Video Products  
Service Bulletin

Model: SLV-353UC/555UC/757UC

No. 131

Subject: Unit Shuts Down (Photo Sensor Kit) Date: September 28, 1990

Symptom:  
(22)

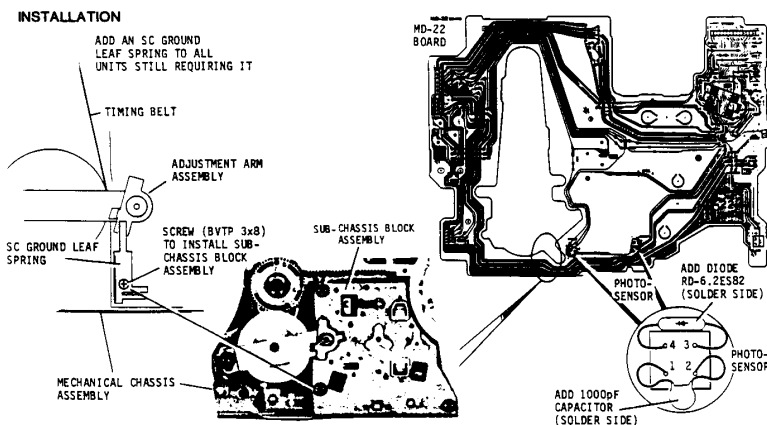
Unit shuts off during PB, REV, FF, or REW.

Solution: A Photo Sensor Kit should be installed whenever any of the above symptoms occur.
